**APPLICATION FOR
HISTORIC AREA WORK PERMIT**
HISTORIC PRESERVATION COMMISSION
301.563.3400

Building Number: 10305 Street: ARMORY AVENUE
Town/City: KENSINGTON Nearest Cross Street: BALTIMORE ST
Lot: 8 Block: 9 Subdivision: 0015 Parcel: _____

10305 ARMORY AVE HAWP PRELIM SUBMISSION

Please find attached response to staff comments provided on April 9, 2024

10305 ARMORY AVE
EXISTING SITE PLAN

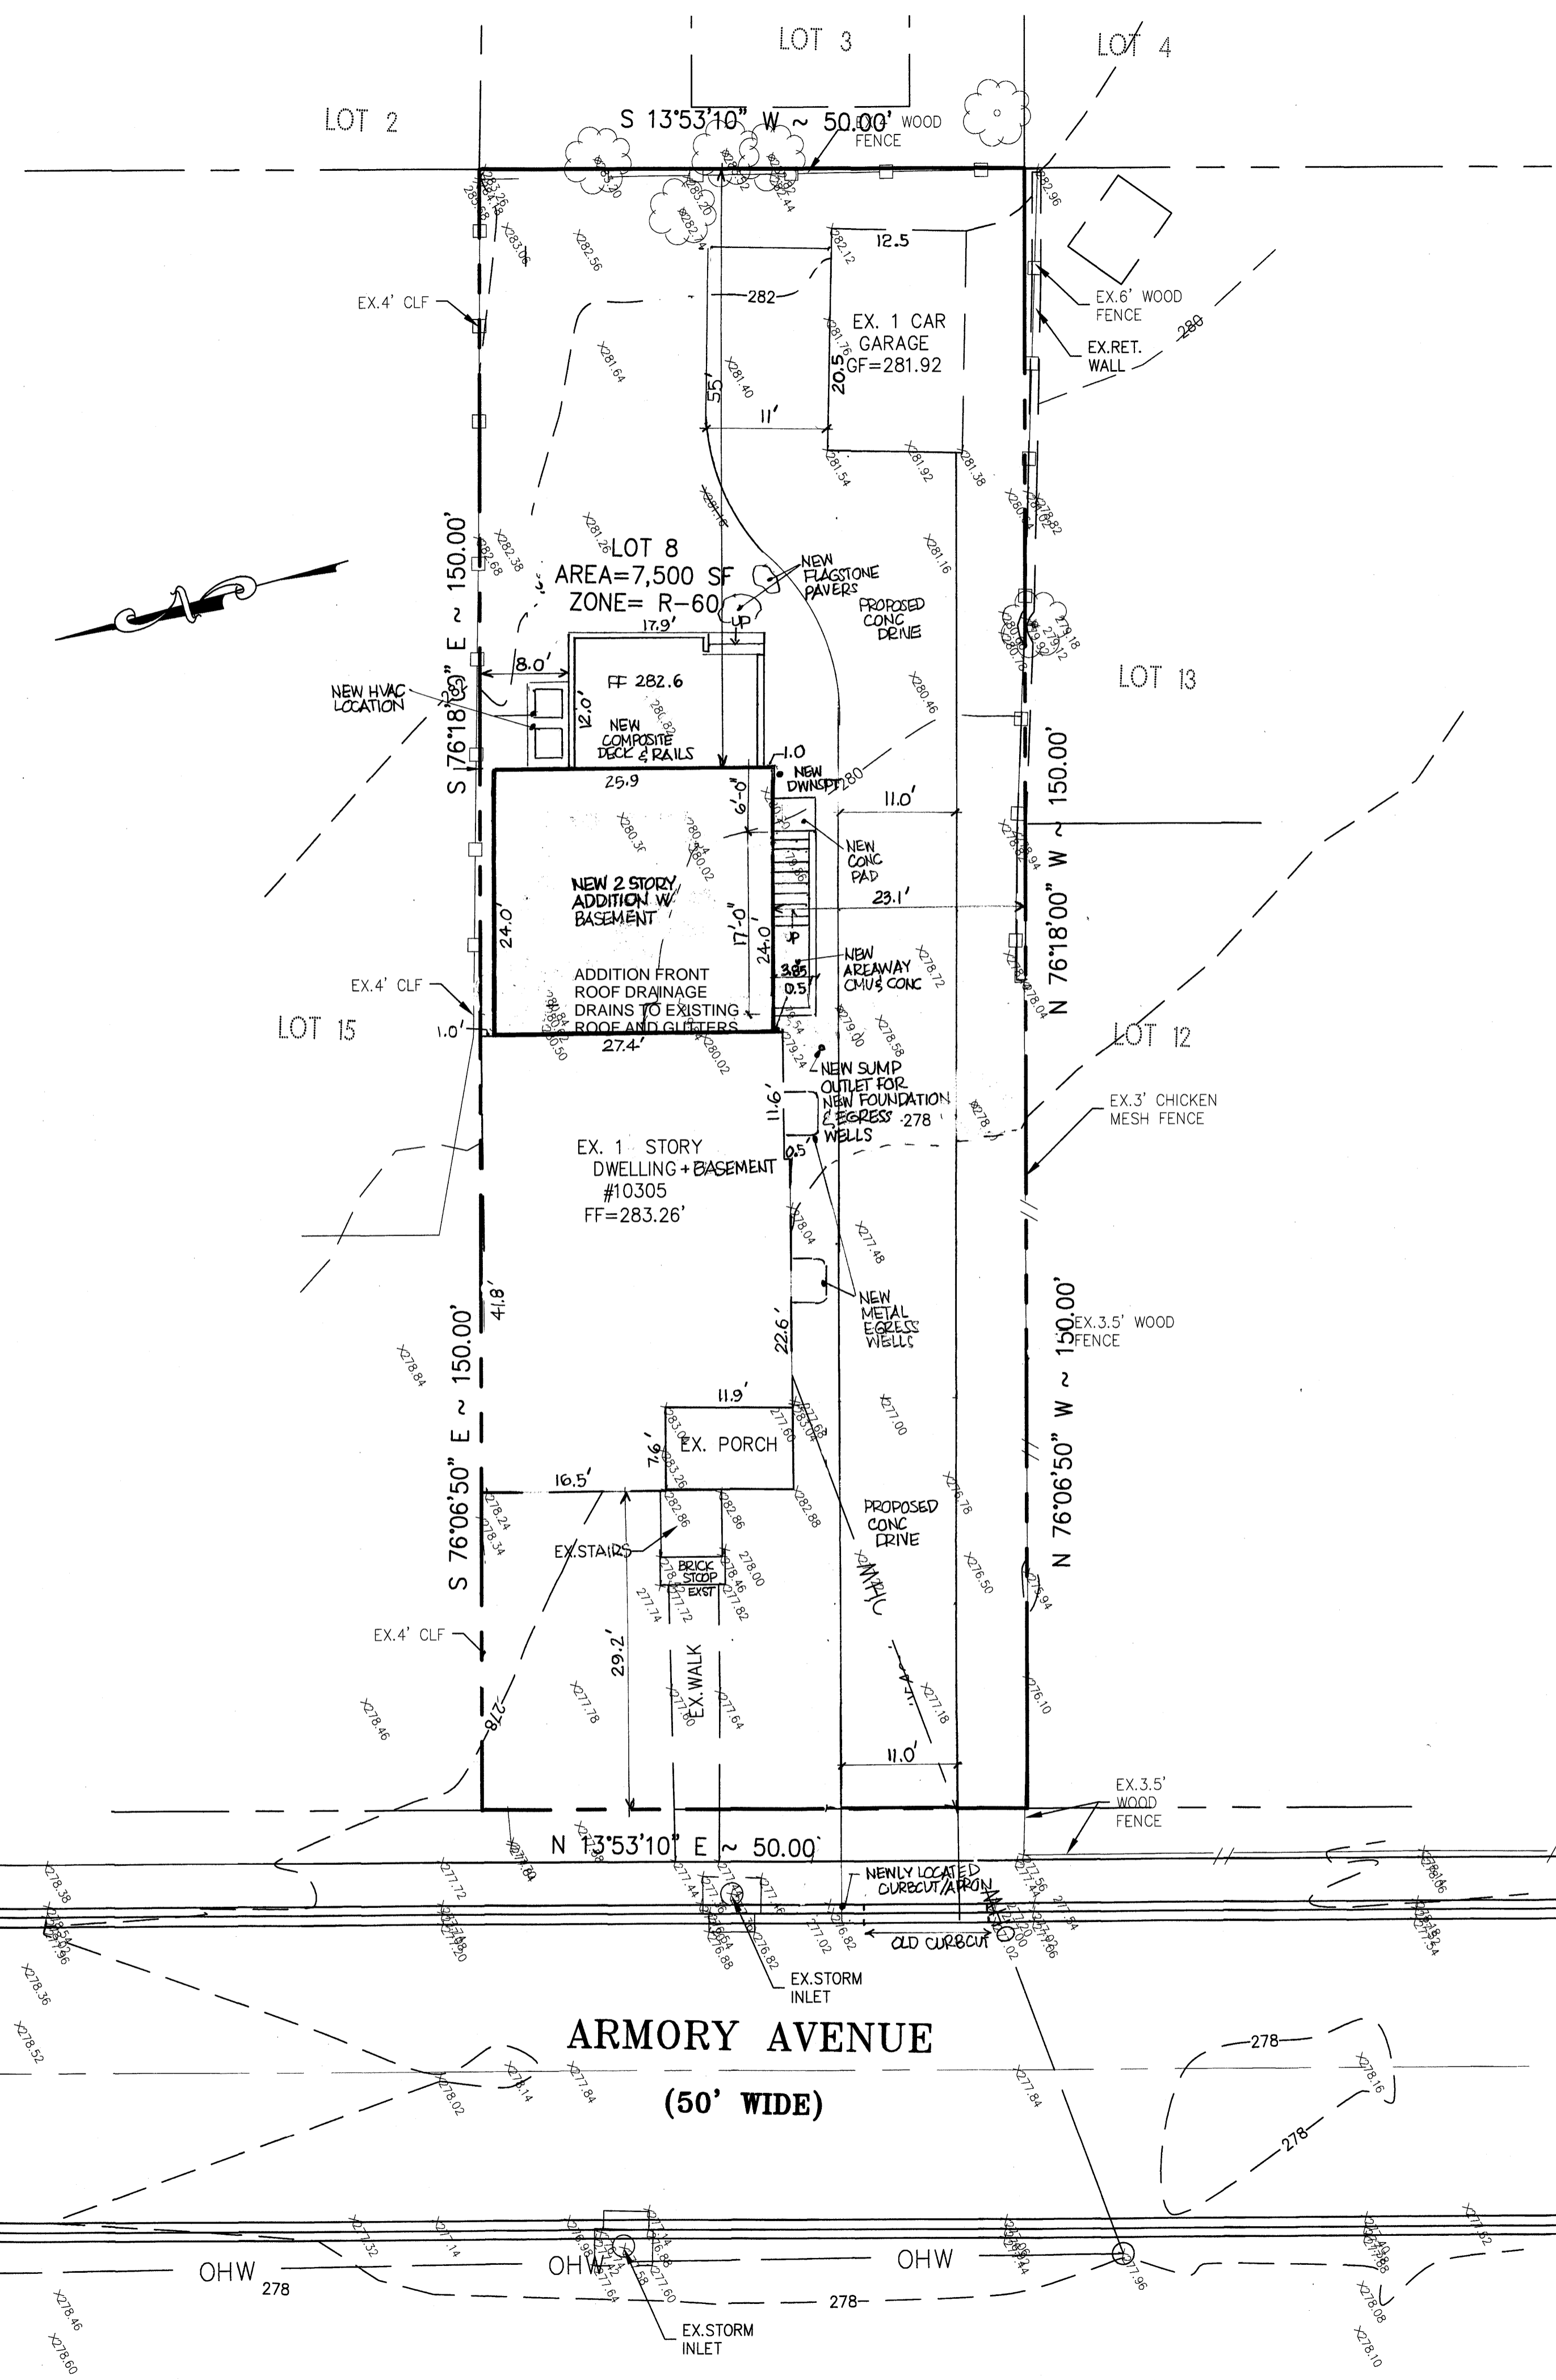
- Include existing and proposed roof pitches on the elevations. [NOW INCLUDED](#)
- Include a detailed existing site plan with dimensions showing the current conditions and a proposed site plan. Include any changes to the site, including tree removals, drainage, etc. [EXISTING AND PROPOSED SITE PLAN NOW INCLUDED.](#)

10305 ARMORY AVE
 KENSINGTON MD
 20895
 A101

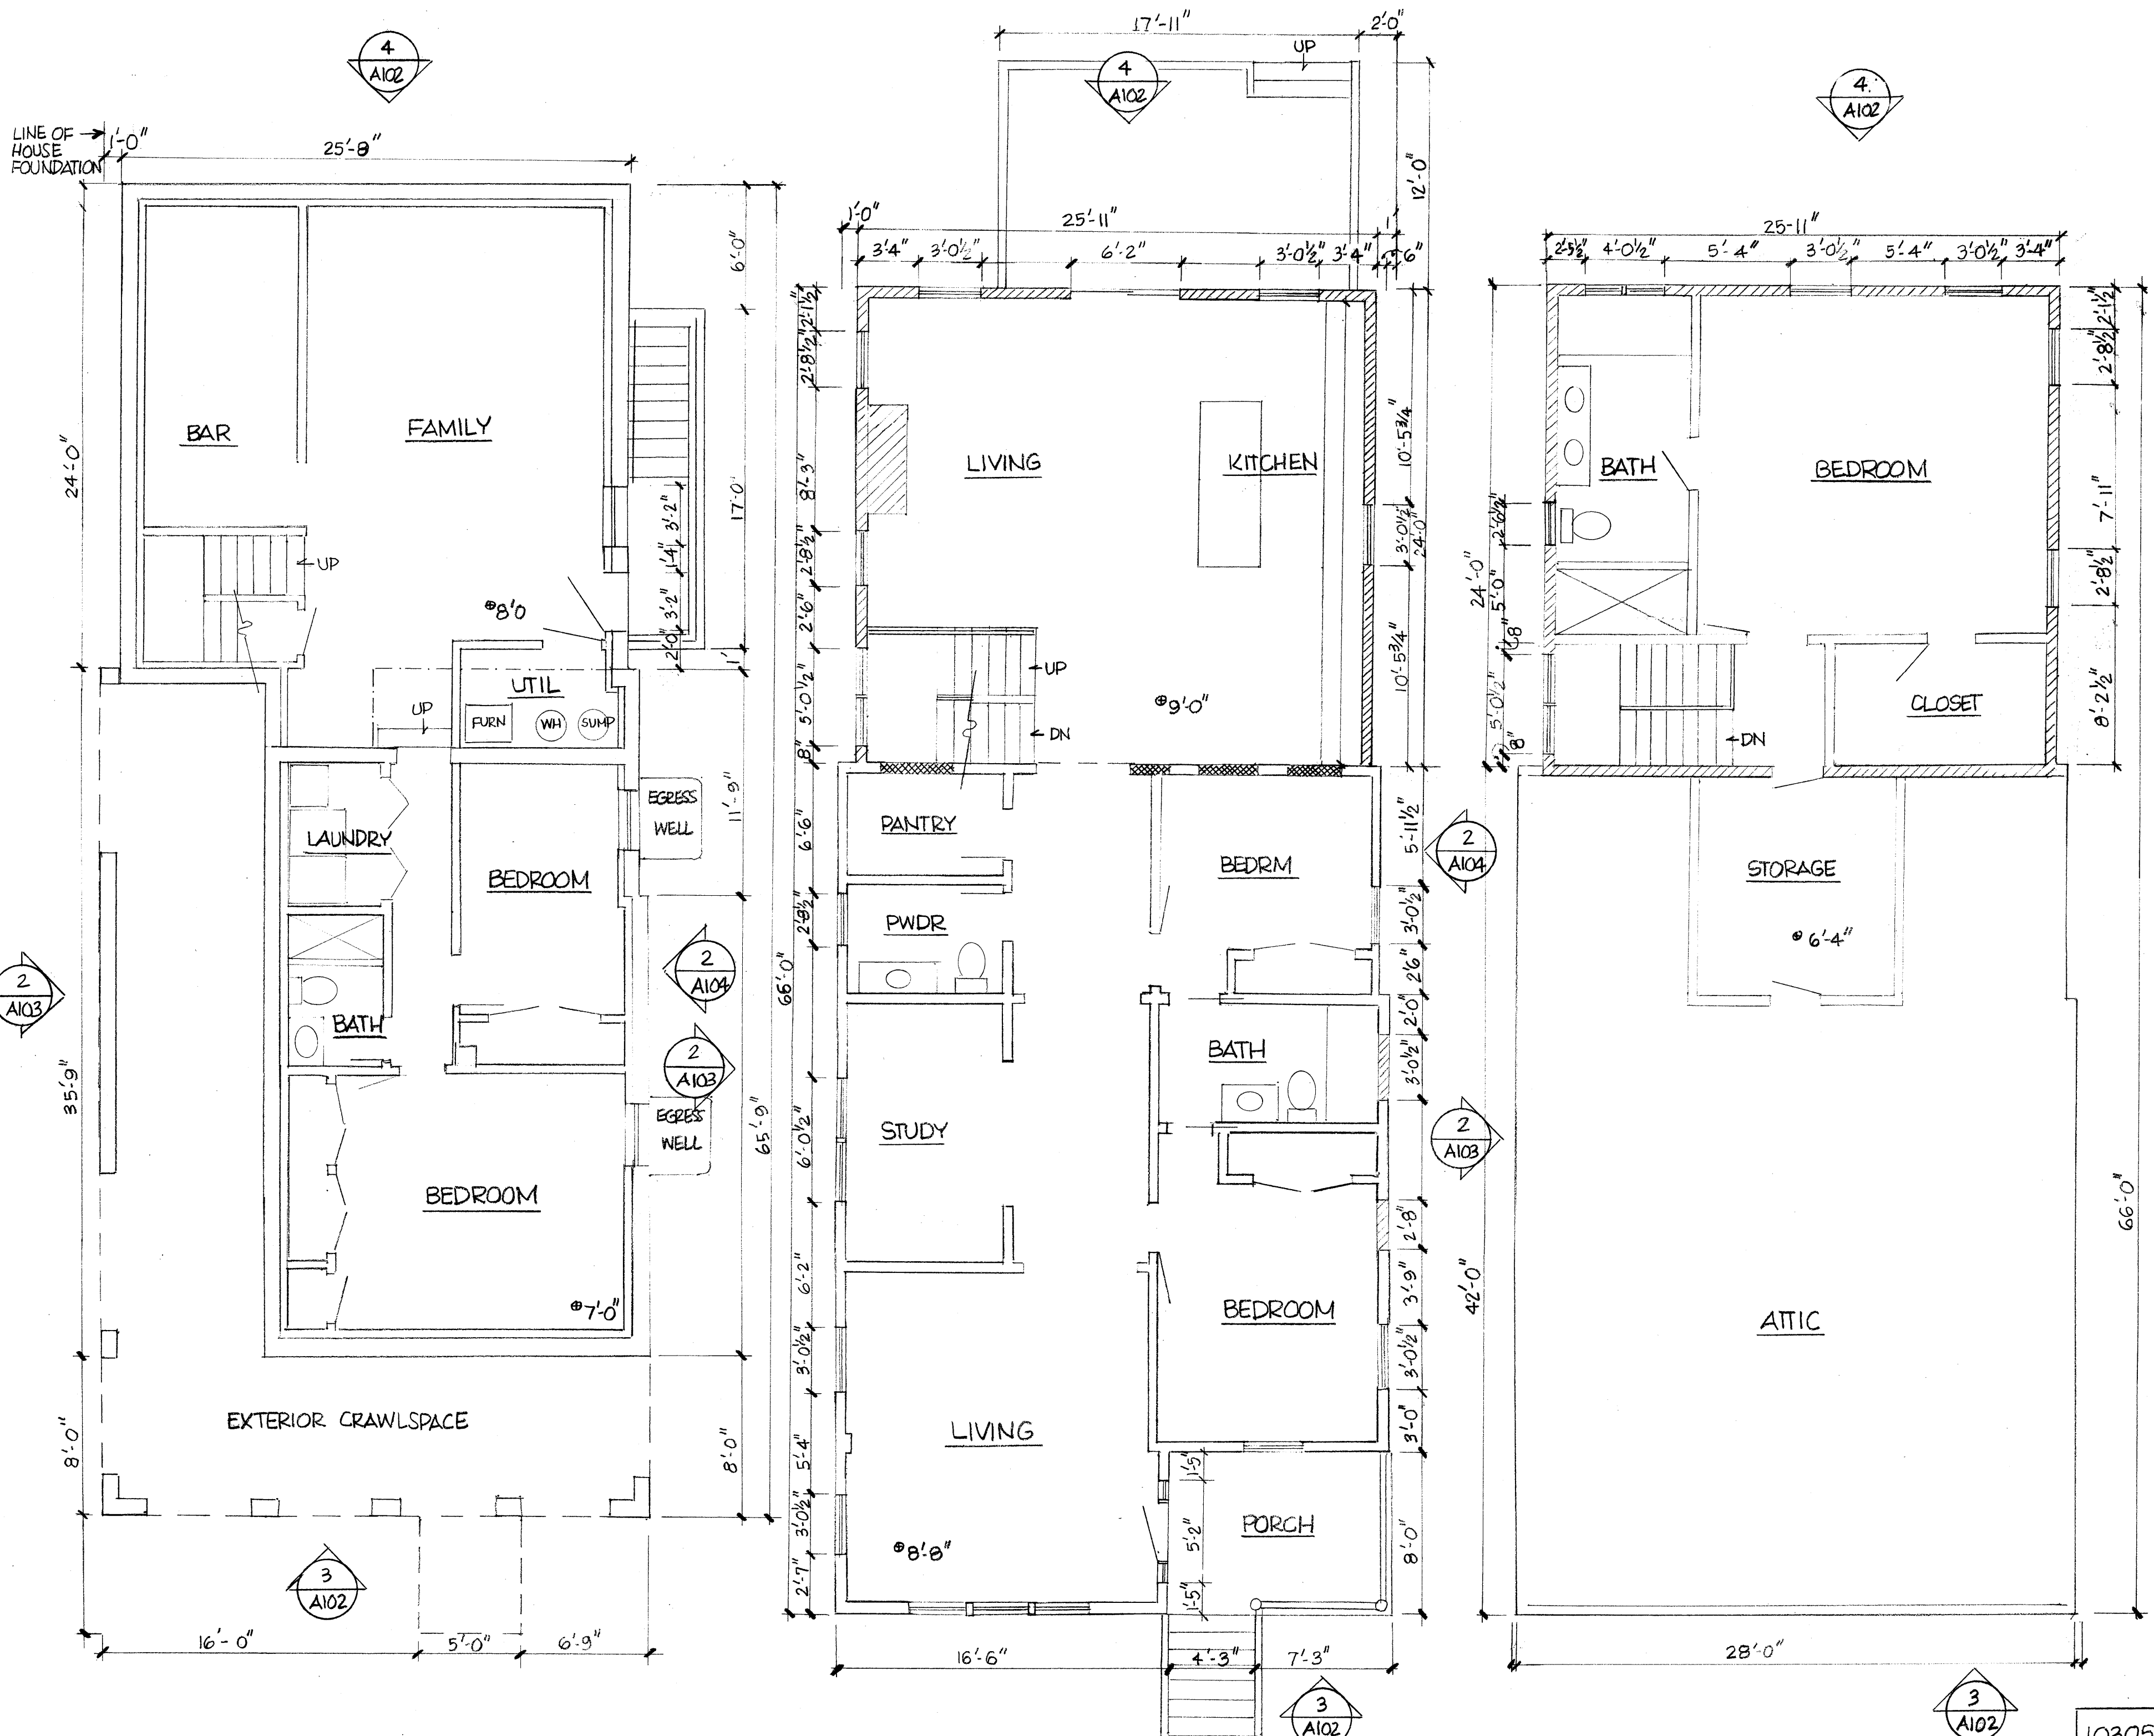
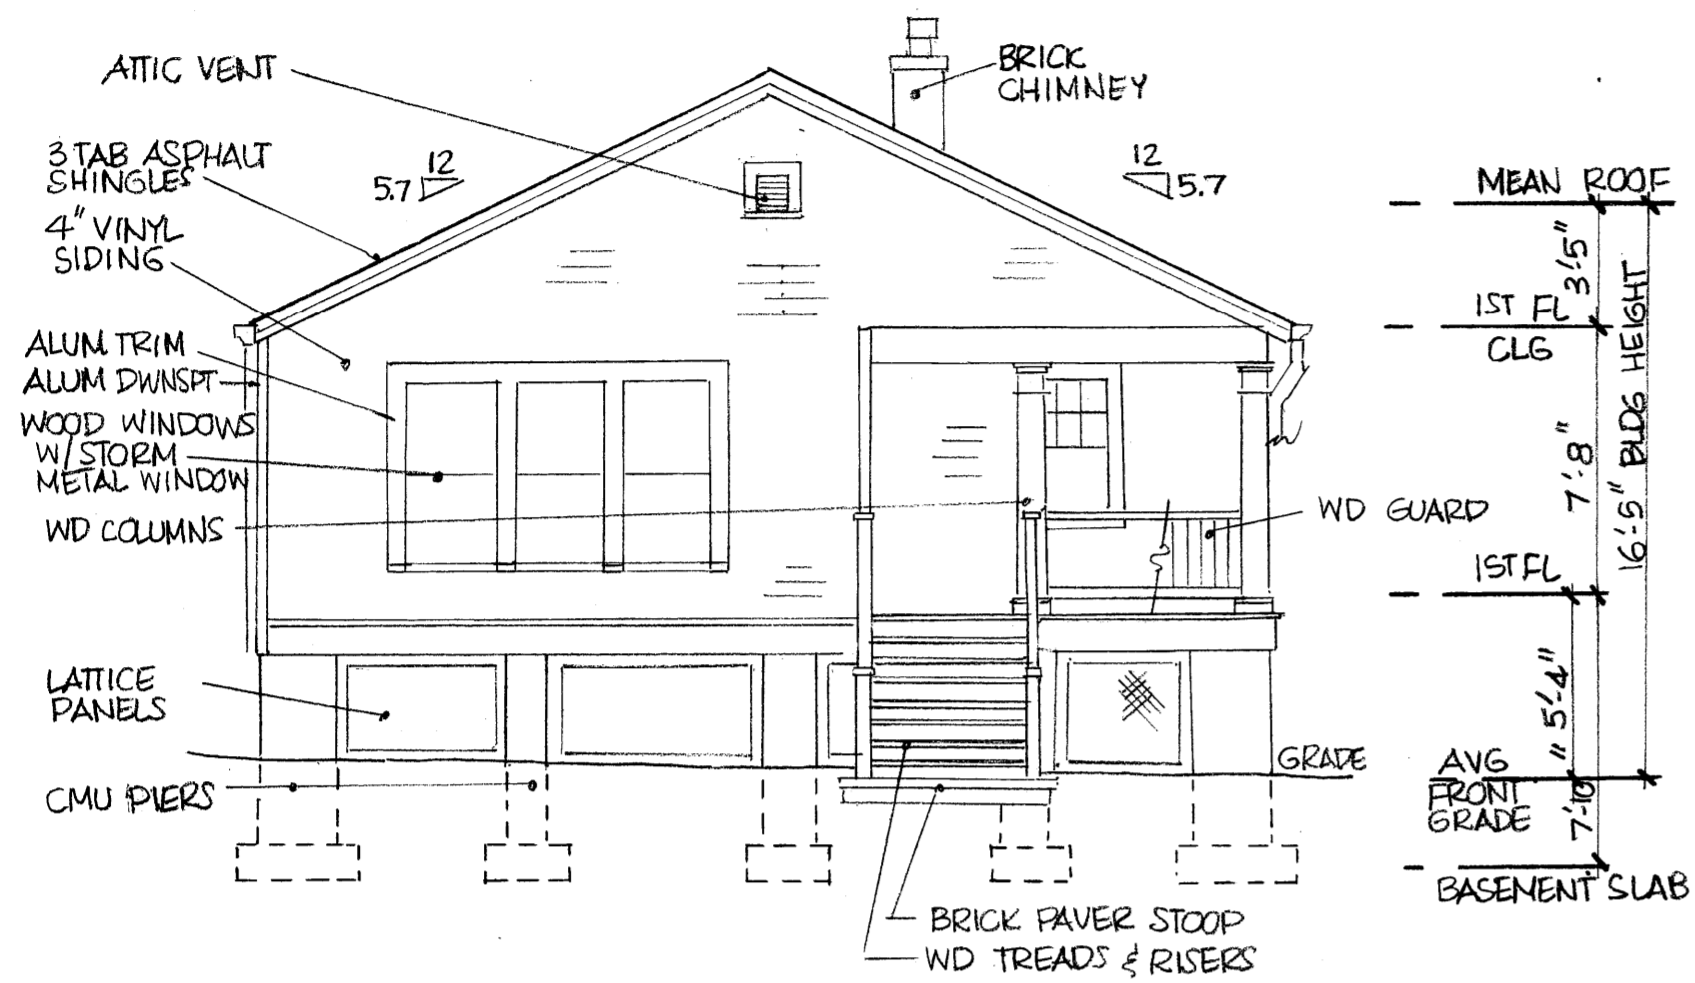
- Inset the rear addition at least 6 inches on both sides. [EXECUTED ON DRAWINGS](#)
- You should restore the existing wood windows. Window restoration is eligible for both 20 percent state historic tax credit and 25 percent county historic tax credit. [THE OWNER /CONTRACTOR FEELS THE WINDOWS NEED TO BE REPLACED AND IS HOPING TO PROVIDE ALL NEW WITH WOOD ONLY ON THE FRONT.](#)
